Hume Coal Project and Berrima Rail Project

State Significant
Development Assessment
(SSD 7172 and SSD 7171)

December 2018

Figure 10 | Bores affected by 2 m or greater drawdown (at the 67th percentile)

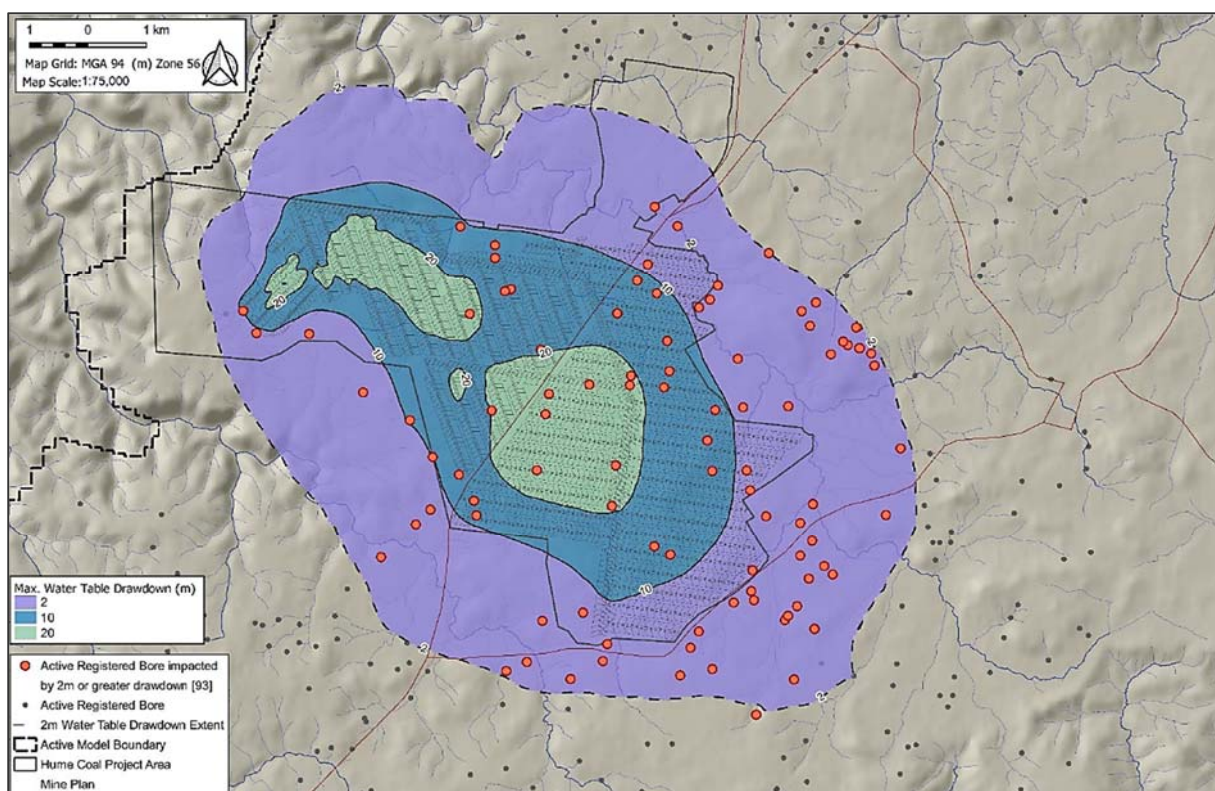
While the *Aquifer Interference Policy* defines more than a 'minimal impact' as over 2 m, there are a substantial number of bores with predicted drawdown much greater than that (e.g. 54 bores with more than 5 m). **Table 8** summarises the number of the affected bores per depth of impact (at the 67th percentile).

Figure 12 | Pillar types in the 'pine feather' mining method

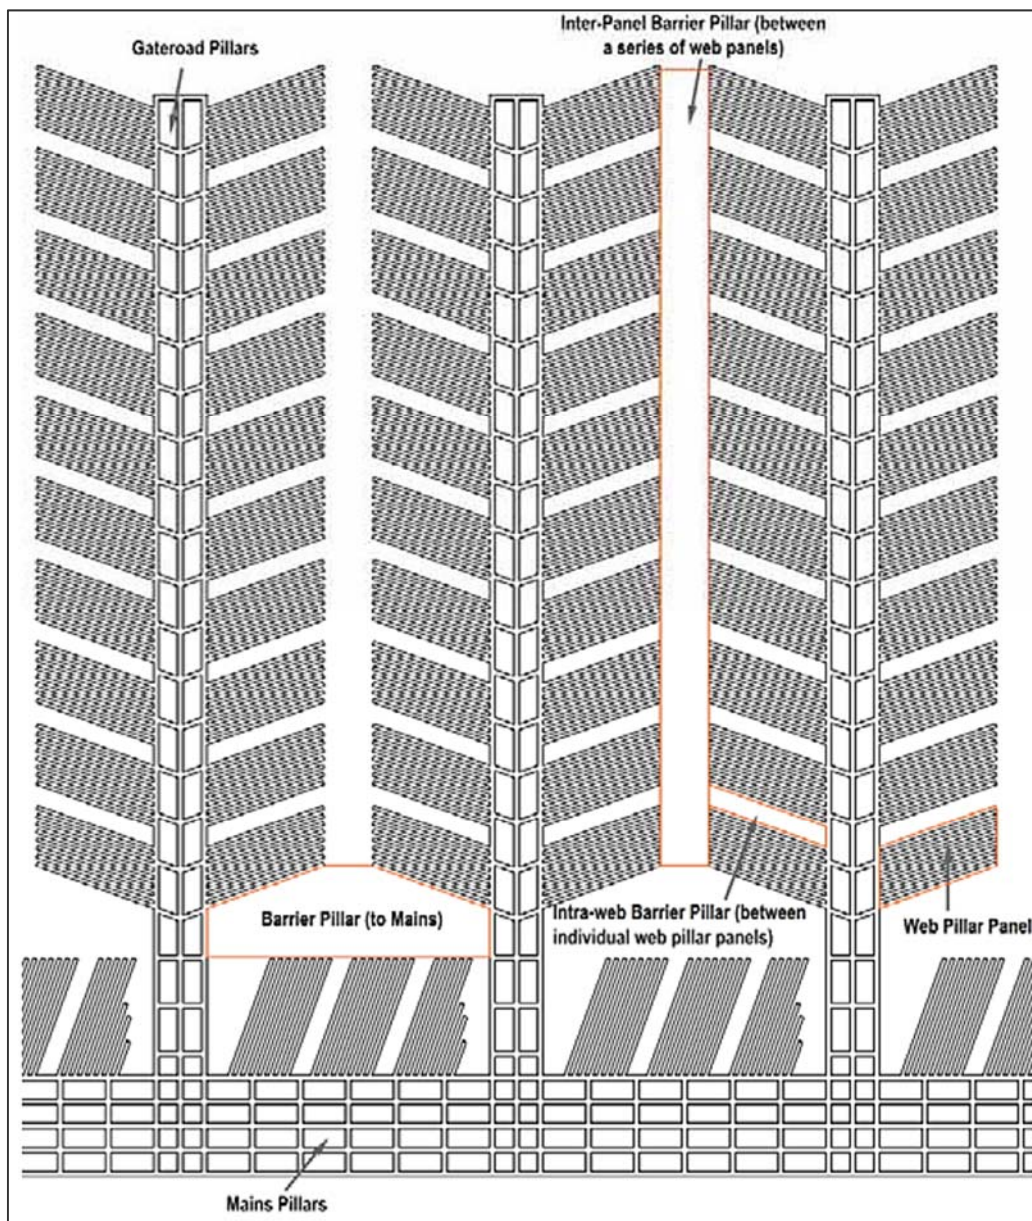
In summary, the proposed pine feather mining method is unique to NSW and Australia. While it has some similarities to underground bord and pillar mining and above-ground highwall mining, there are some significant differences to each of these methods. The proposed mining method relies on a range of pillars, and the stability of these pillars is a fundamental consideration in assessing potential impacts.
